IE Bulletin 79-05B

NUCLEAR INCIDENT AT THREE MILE ISLAND - SUPPLEMENT

EXTRACT OF B&W COMMUNICATION - RECEIVED BY NRC
4/20/79

Figure 1

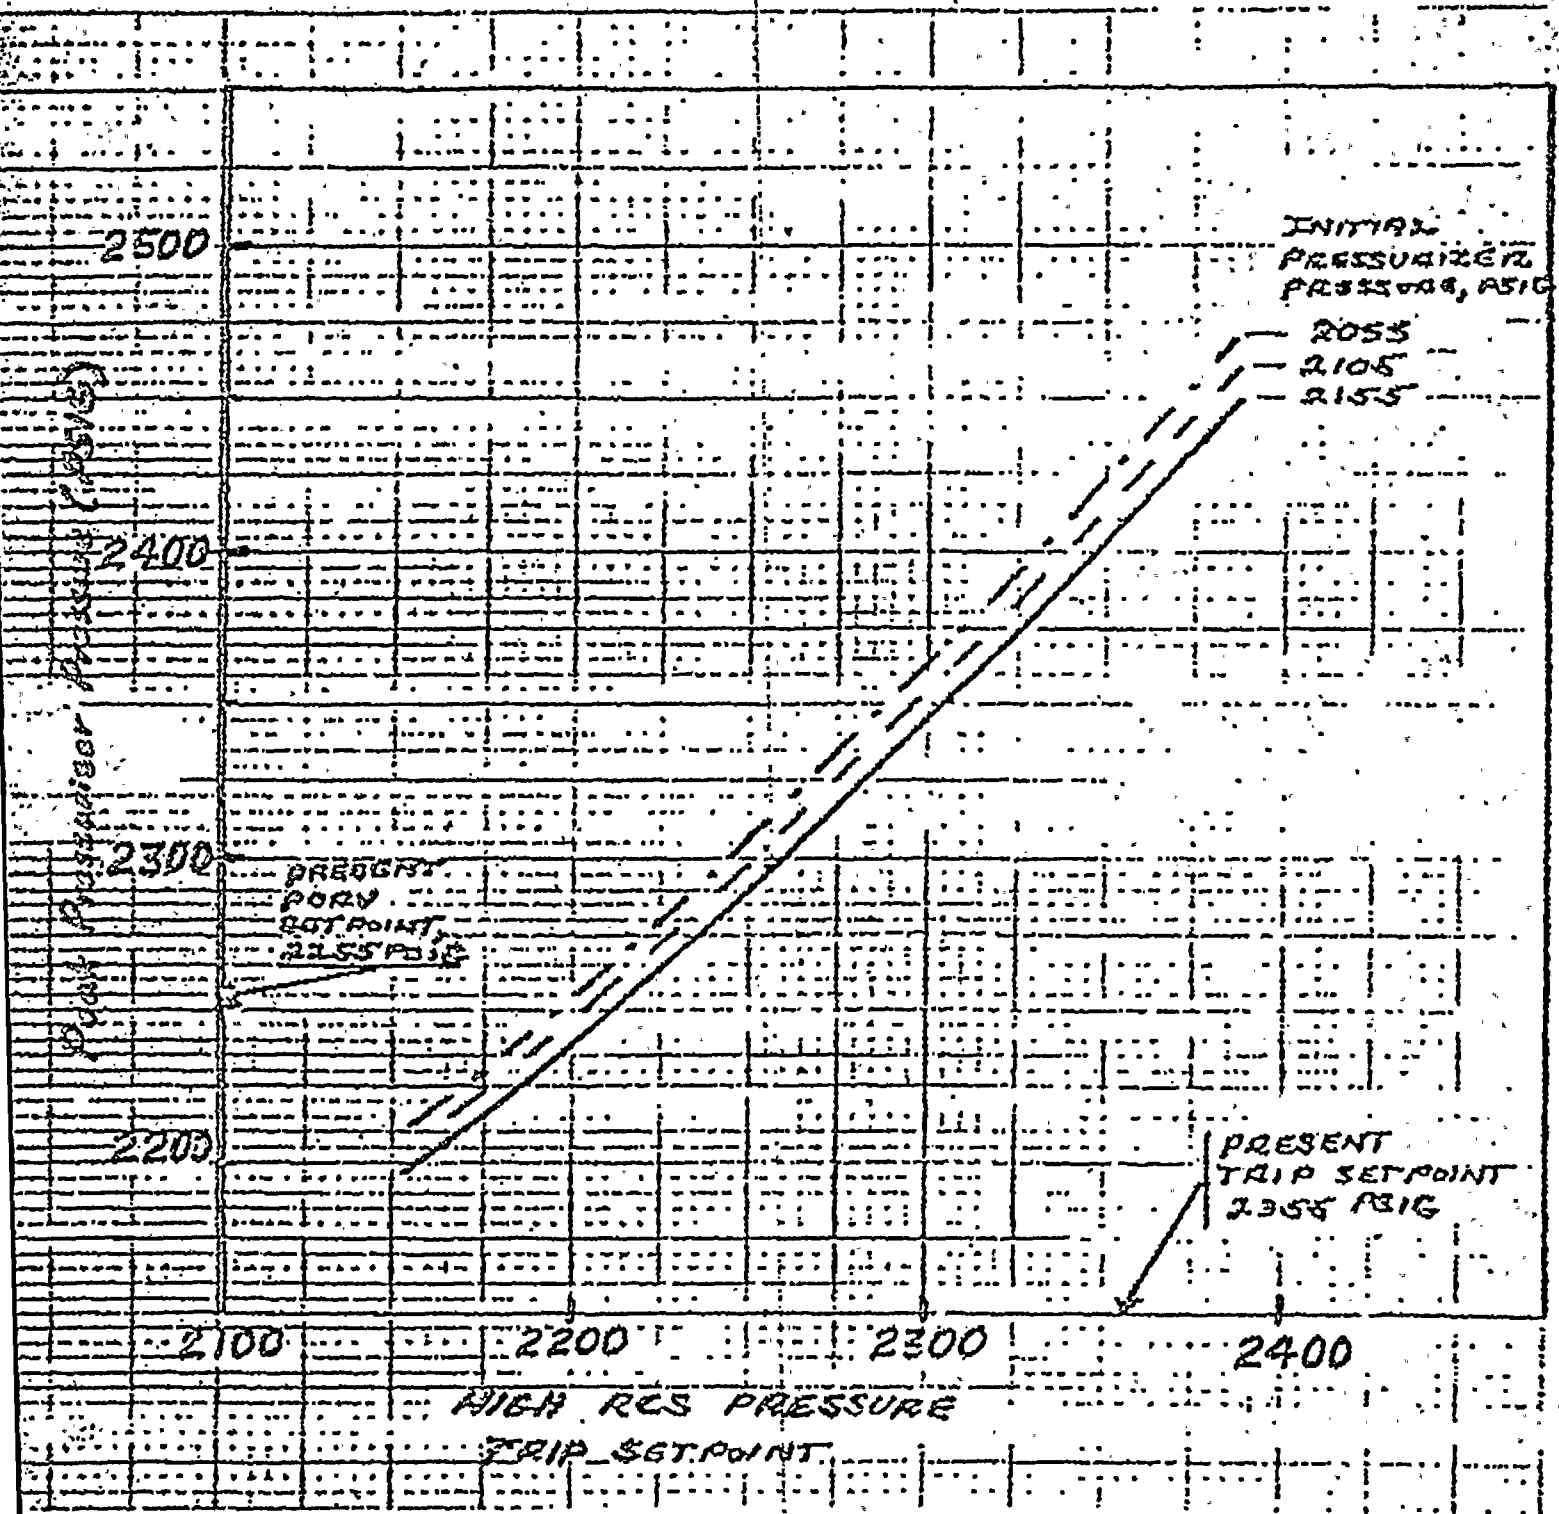
LOWERING THE HIGH PRESSURE REACTOR TRIP SETPOINT FROM 2335 PSIG TO 2300 PSIG

RAISING THE SETPOINT FOR THE PILOT OPERATED RELIEF VALVE FROM 2255 PSIG TO 2450 PSIG

The effect of changing the reactor coolant system pressure trip setpoint upon peak pressurizer pressure is typified by the attached figure 1. which was developed by B&W for a loss of feedwater transient.
